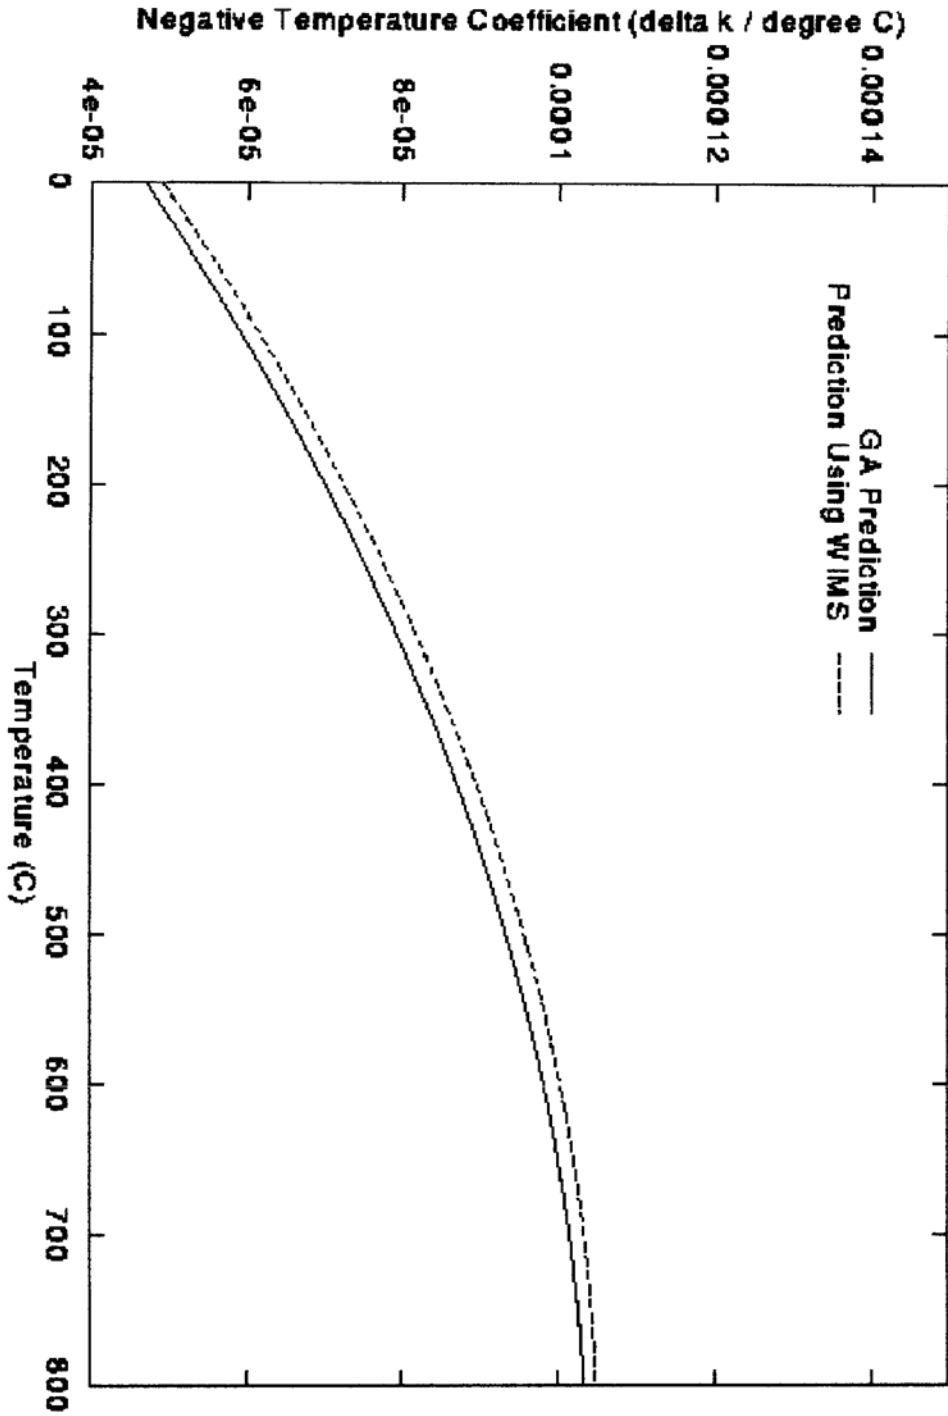
4-21 On page 4-67, Figure 4.33 is referenced as showing the temperature coefficient for 20/20 fuel, however, the Figure 4.33 on page 4-69 shows a fuel map. Provide the correct figure. Open, supplement expected with the correct figure.
